## APPROVAL RESOLUTION NO. 16-03

RESOLUTION OF THE TOWN OF ST. LEO TOWN COMMISSION APPROVING SPR/VAR #14-A, MINOR MODIFICATION #2, GRANTING A VARIANCE TO LAND DEVELOPMENT CODE SECTION 12.2. LANDSCAPE BUFFERS BETWEEN INCOMPATIBLE USES TO PROVIDE THE LANDSCAPE BUFFER ON THE INSIDE OF THE FENCE AND GRANTING APPROVAL OF THE REVISED LANDSCAPE PLAN FOR THE SAINT LEO UNIVERSITY PLANT OPERATIONS FACILITY WITH CONDITIONS.

**SITE/LANDSCAPE PLAN REVIEW (SPR) STAFF REPORT**  
**SPR/VAR#14-A, Minor Modification #2: Saint Leo University Plant Operations Project**  
**Town Commission Meeting December 14, 2015**

## Proposed Revised Landscape Plan

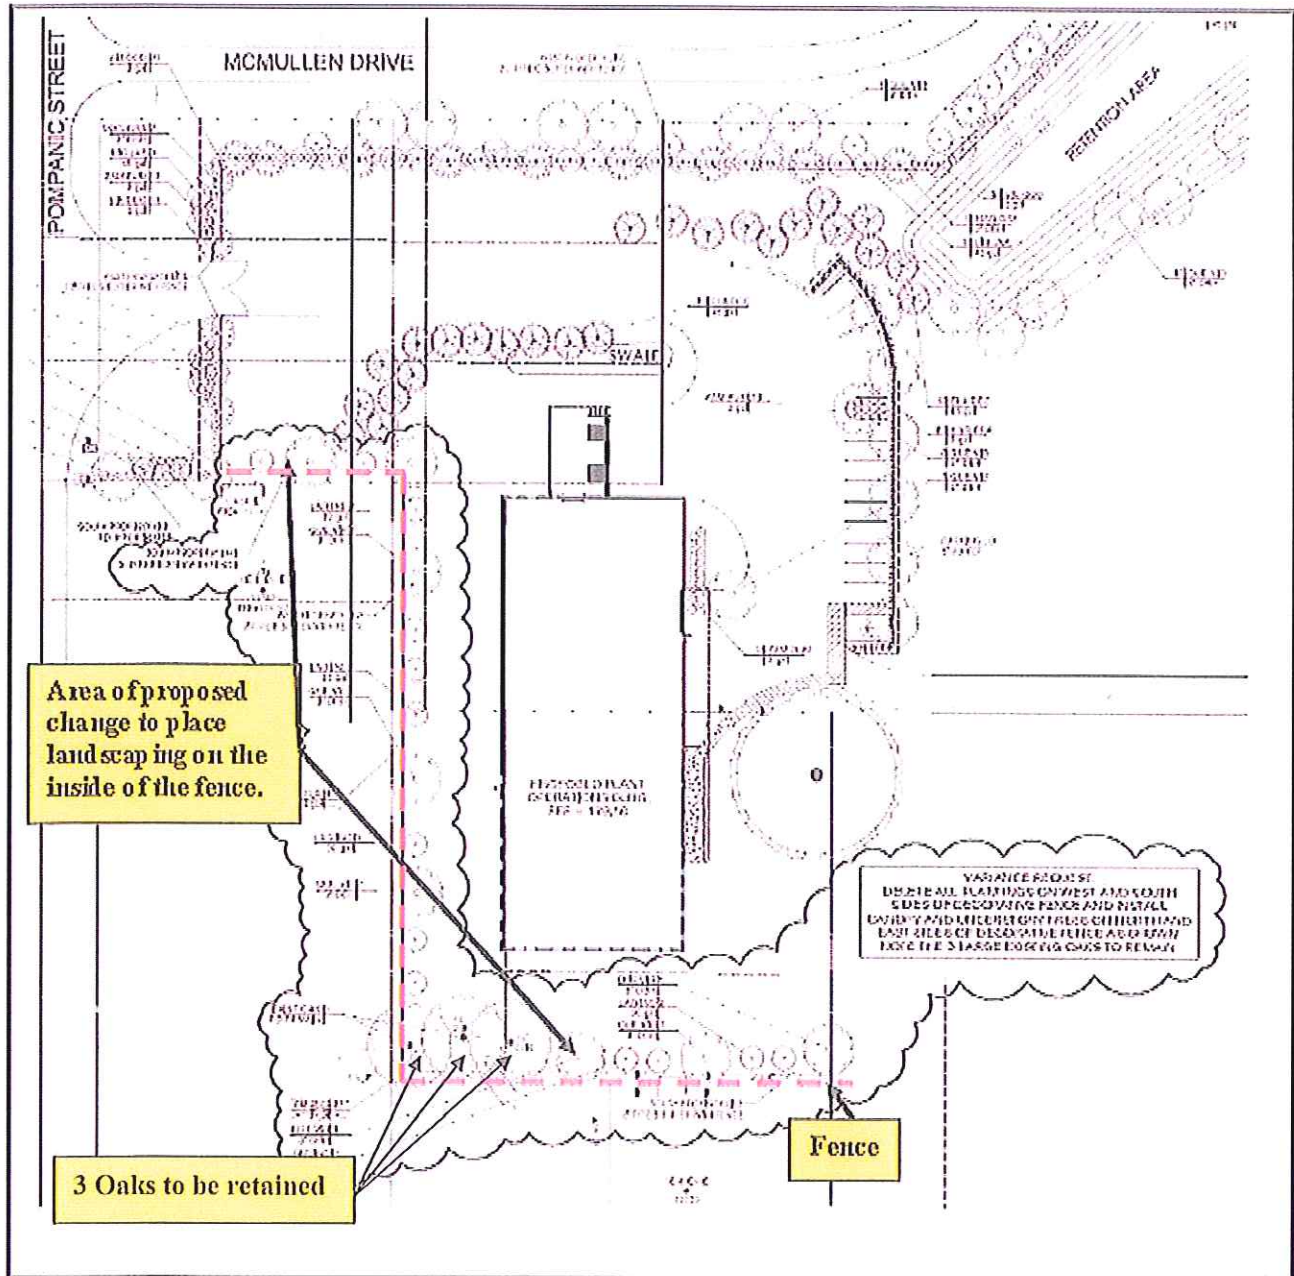
1. To meet the required landscape buffer width and planting requirement, but place the landscaping on the inside of the fence along the west and south boundaries (Exhibit B). There is no change to the location of the landscaping along McMullen Drive or Pompano Street, which is in front of the fence as required.

It is noted that the revised Landscape Plan submitted shows three existing Oaks (46", 32" and 18" DBH) located at the southwestern corner of the property are to be retained. The original approved Landscape Plan did not show these trees to be removed, nor has any tree removal permit been found proposing or approving removal of these trees.

The Applicant has provided a justification narrative addressing the above criteria (Appendix A). The proposed landscaping relocated to the inside the fence meets the landscape buffer planting requirements.

It is noted that the variance request is a self-created hardship as this issue could have been addressed at the original 2014 site plan review submission, and further, there are other options for achieving compliance:

1. Negotiate a letter of agreement with the adjacent property owners granting the University permission to access the landscape buffer for maintenance purposes, or
2. Add gates to the existing fence in order to access the landscaping for maintenance, or
3. Move the fence back another five (5) feet allowing sufficient room to conduct maintenance.

Implementation of any of the above would not deprive reasonable use of the property; again as noted, this is a self-created hardship, not due to any LDC requirement or unreasonable conditions that have been placed on the previous development approvals for the Plant Operations facility.

The Town Commission APPROVES SPR/VAR #14-A Minor Modification #2 Granting Approval of the Requested Variance to provide the landscape buffer on the inside of the fence and Granting Approval of the Revised Landscape Plan for the Plant Operations project as submitted (Exhibit B and Appendix A). The project remains subject to the conditions of SPR/VAR#14-A approved on August 11, 2014 and Minor Modification #1 approved on October 12, 2015.

L-101

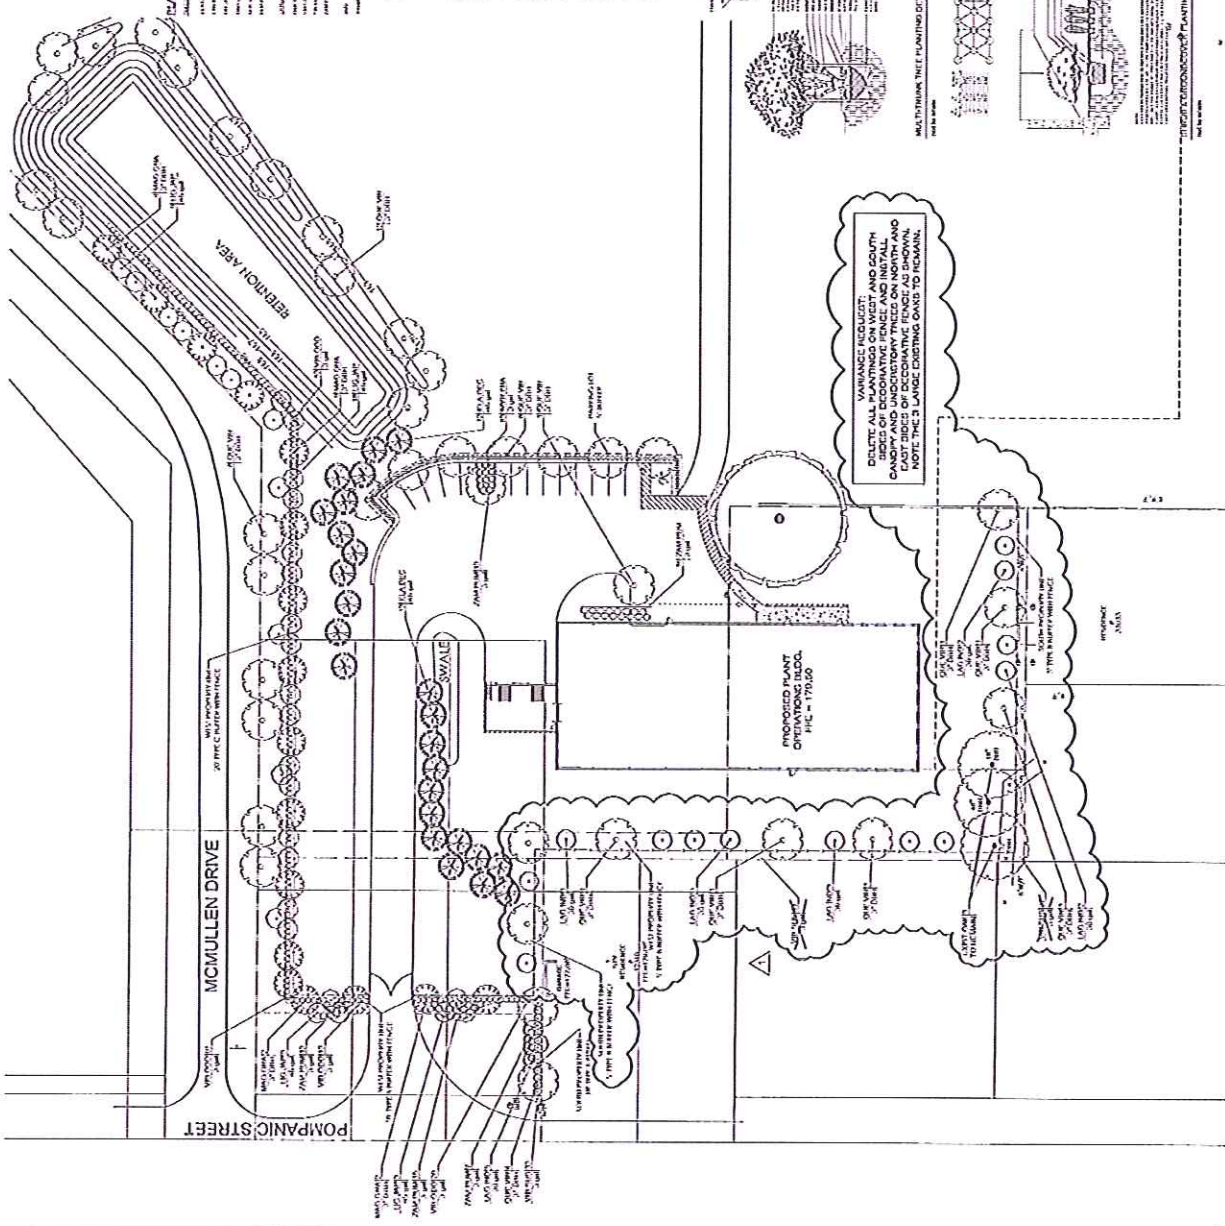
1. Along the west and south property line immediately opposite the new plant operations building, delete all the buffer plantings in the 5' landscape strip between the property line and 6' vinyl decorative fence and instead, in order to still provide a visual buffer, install the same number of canopy trees and understory trees on the university side of the fence, as shown on the accompanying plan.

The Plant Operations Site Plan Review approval calls for a solid fence and 5' wide landscape planting strip, with the landscape strip facing the adjacent property owners. The landscape is a combination shrubs (Ligustrum), understory trees (Crape Myrtle) and canopy trees (Live Oak).

The dilemma is that a 5' wide planting strip is not wide enough to provide access to the plants for maintenance. The university would have to trespass on private property with personnel and vehicles which is clearly an undesirable and unworkable situation.

The intent of the ordinance is to provide a visual buffer between the different land uses. In keeping with the intent of the ordinance the university proposes to install the same number of understory and canopy trees on the plant operations side of the solid decorative fence. The tree foliage will provide the same amount of visual buffer regardless of what side of the fence it is planted. By virtue of being on the plant operations side the trees can be properly accessed and maintained by the university without trespassing on private property.
